Mary River Drawing

4.0 MILNE INLET

Hazardous Waste Storage MP-HWB-3

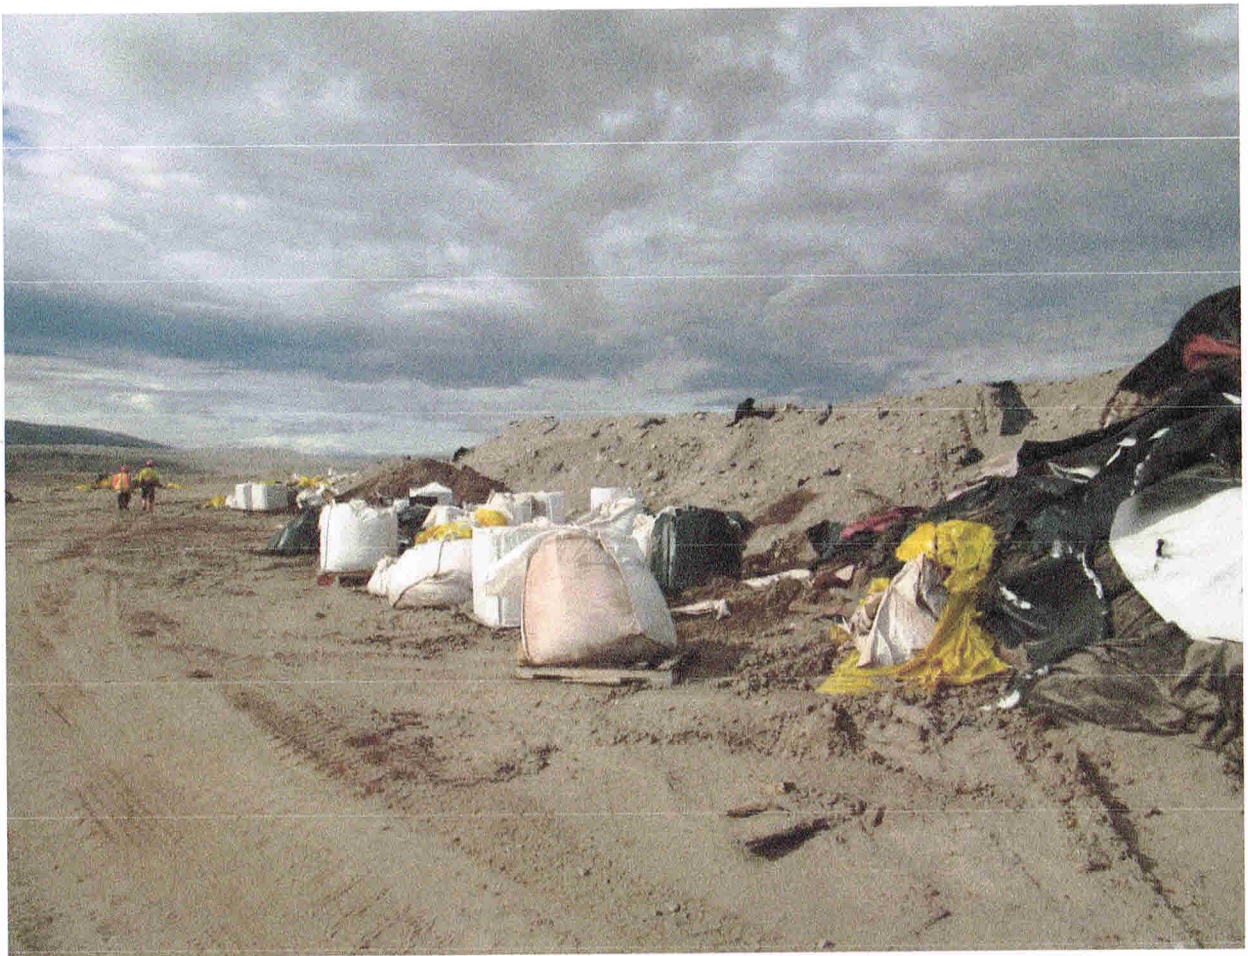
This particular structure has been constructed as a two-cell structure and is now only used to store a few items.

There is no water ponding in both cells of the original structure. We are advised that water has been pumped from these structures and sand in the structures is wet.

Our review of the area around the dykes, at the base of the slopes, showed no sign of seepage. The structure is considered stable.

We have no recommendations with respect to the use of these two cells at this time. Prior to our inspection in September, we request that water not be pumped from the structures.
